HEARING REPORT
NOTICE OF REQUIREMENT
WHENUAPAI WASTEWATER SERVICING
SCHEME PACKAGE 1
WATERCARE SERVICES LIMITED

**A NOTIFIED NOTICE OF REQUIREMENT TO THE AUCKLAND COUNCIL UNITARY PLAN
BY WATERCARE SERVICES LIMITED**

Reporting on proposed Notice of Requirement for the construction, operation and maintenance of the proposed Whenuapai Wastewater Servicing Scheme – Package 1 Project (the Project), which includes a gravity main, pump station, rising main, and associated infrastructure. The reporting officer is recommending the notice of requirement by Watercare, be modified and be subject to the amended and additional conditions.

Figure 2 – Potential alternative routes around Wetland C.

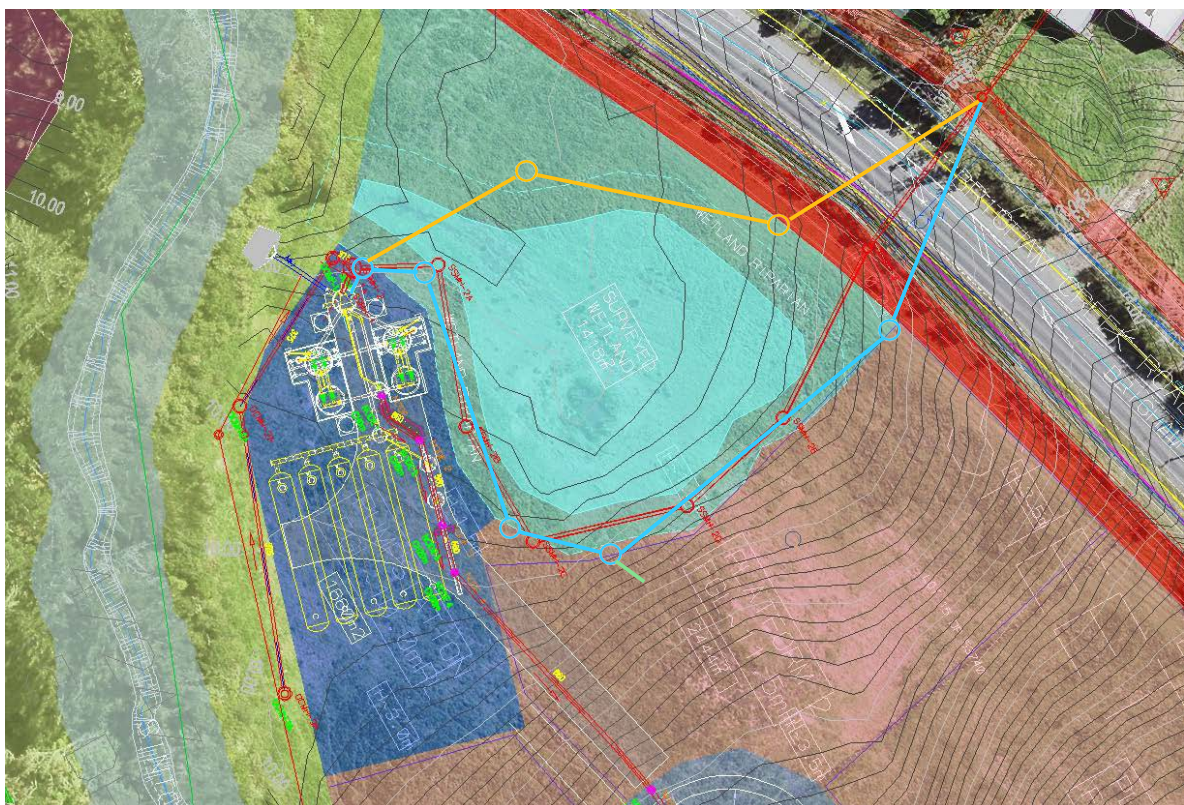
A simple review of the design drawings against site contours quickly identified this assessment to be unreliable. Watercare have since conceded that the actual depths of manholes required along an eastern alignment is at approximately the same depth as other parts of the gravity alignment as shown on the longsection included in the Watercare Services Limited response 19 January 2024. The number of manholes shown on the Plan is also considered to be an inefficient design. A more efficient layout such as the route indicated in blue on Figure 2 below would reduce the number of manholes. What this design does show is that it is fully possible to route the gravity sewer around Wetland C. This route would also avoid the pipeline passing through possible Wetland D. Therefore, by function, there is no need for the pipeline to pass through the wetland.

Another option which may largely avoid Wetland C is indicated in orange on Figure 2, acknowledging that this would still pass through the toe of the wetland, but would have a lesser footprint in the wetland area. This is in the general location of Option F in the Alternatives Assessment, which was only ruled out for the following reason:

However, if this option follows an alignment similar to that shown on Figure 2, rather following the road alignment for no reason, then the only stated reason to discount this option falls away, and it becomes entirely viable with essentially no increase in pipeline length.

Figure 3-2: Contractor Area Hub Layout

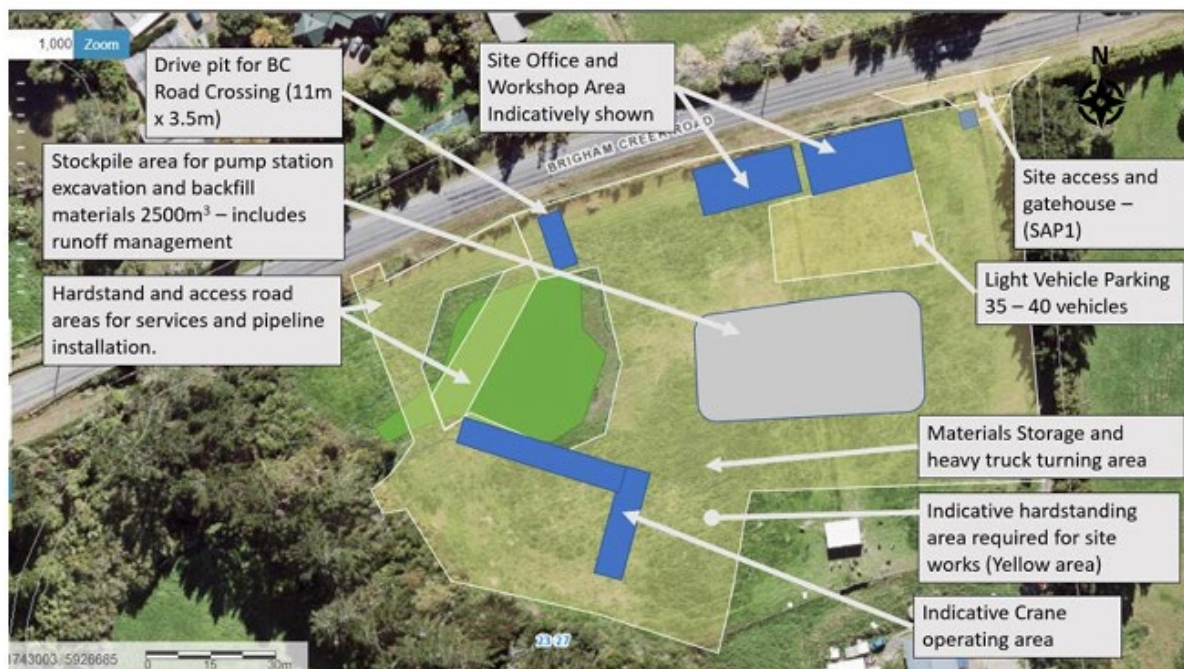
Finally, Figure 3-2 of the Traffic Impact Assessment Report indicates the Requiring Authorities intention to not only install the gravity sewer within Wetland C, but to use it as a general access road during the pump station construction. Trenching through the wetland is indicated as being less than 2.5m deep, and should be able to be constructed without the need for a hardstand, and with a footprint minimised by the use of trench shields. I am of the opinion that the access road and wide designation boundary through Wetland C does not reflect any attempt to minimise effects on the environment.

Figure 3: Pump station access road and wetlands

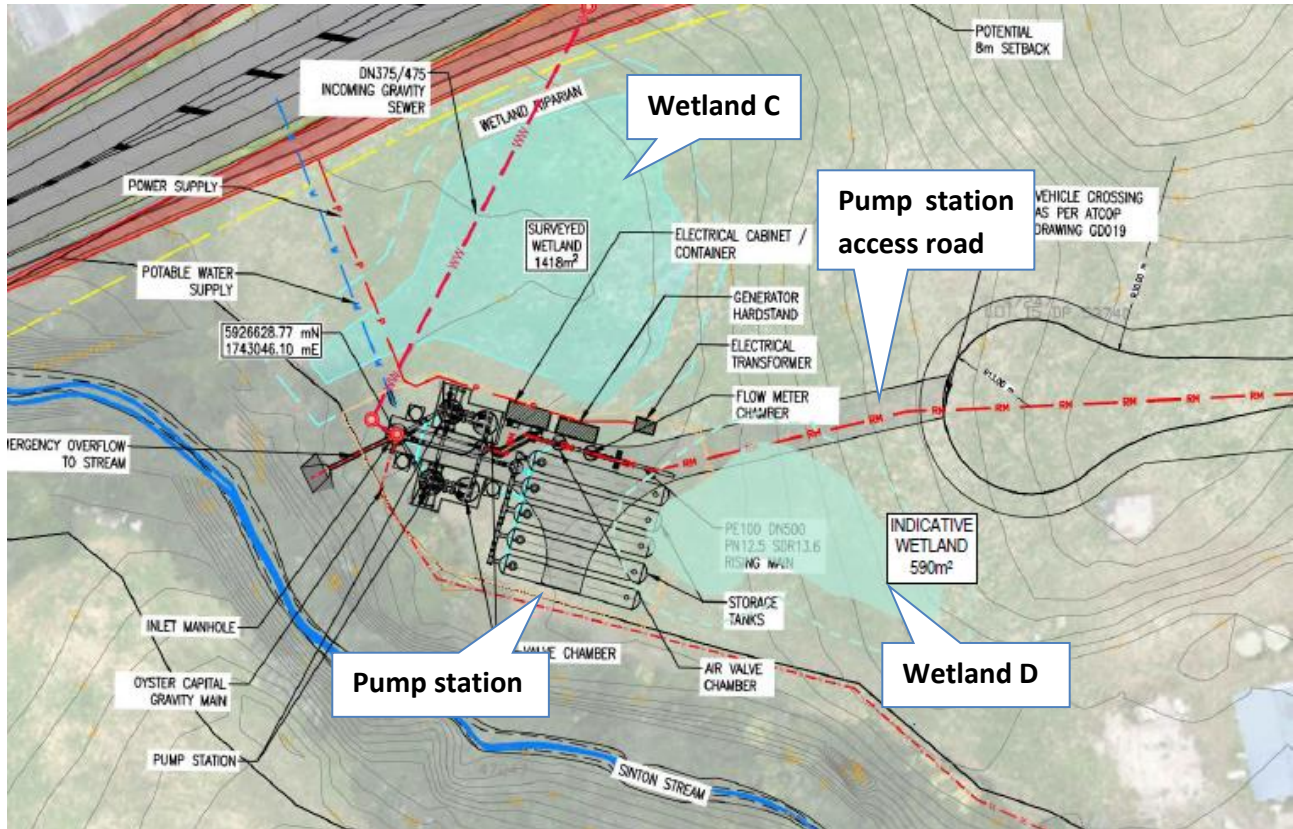
During my review, I asked the applicant to provide further information for truck manoeuvring at the proposed pump station, to ensure a truck could enter and exit the site in a forward direction. During earlier Section 92 responses, the applicant provided vehicle tracking which demonstrated a large rigid truck could undertake a three point turn within the site, to avoid reversing onto Brigham Creek Road.

As a point to note, the access road for the pump station appears to overlap with Wetland D, as shown in Figure 3. This access road would accommodate truck manoeuvring to service the pump station. This access road would also be permanent, and service the pump station post construction.

Outcome: Concerns addressed as truck manoeuvring as allowed for on-site

Figure 5: Trig Road / Spedding Road – construction vehicle tracking for left out movement (from applicant’s Traffic Impact Assessment)

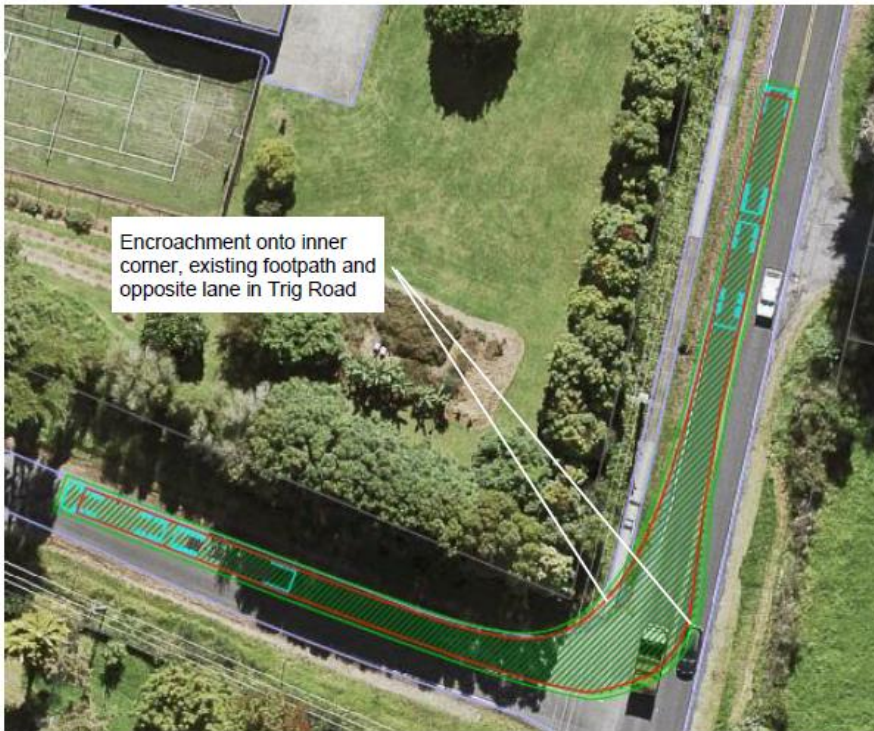
The submitter stated that they do not support right turns, given it may require localised widening. Based on the assessment provided by the applicant, the right turning movements at the Trig Road / Spedding Road intersection do not require any widening. Instead, it is the left-out movement from Spedding Road

into Trig Road that may require widening, as shown in Figure 5 and Figure 6. I have assumed that the submitter is seeking to restrict these left turns.

Figure 6: Trig Road / Spedding Road – construction vehicle tracking for left out movement with possible widening (from applicant’s Traffic Impact Assessment)

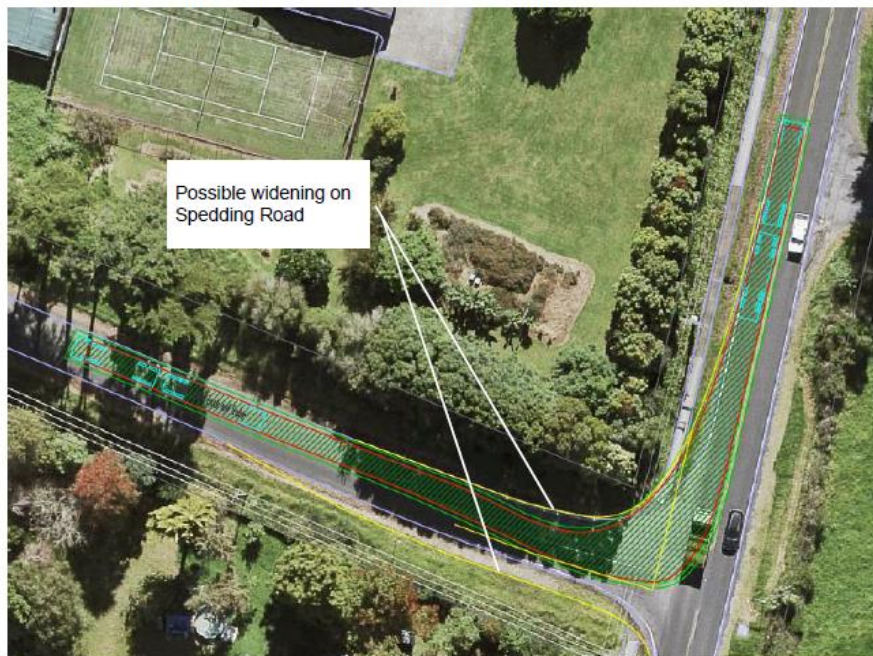
The submitter's concern is that accommodating the turning movement may require road widening near their landholding at 90 Trig Road. The possible road widening shown in Figure 6 appears to be fully within the road reserve, and not within the submitter's site.

Figure 2. Permanent Stream, overland flow paths, flood prone, flood sensitive, floodplains, NoR and contours and surrounding environment for the proposed NoR for wastewater infrastructure in Whenuapai, Auckland Council GeoMaps, June 2024

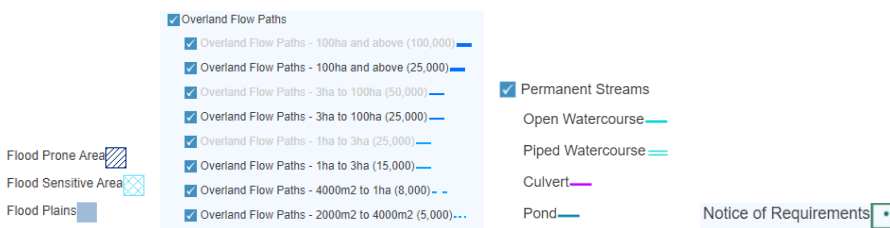
Commented [TE4]: Can you please provide a concluding comment if you consider the assessment to be sound?

Commented [LT5R4]: Is 4.4 alright? as section 3.0 is an outline for Watercare’s assessment.
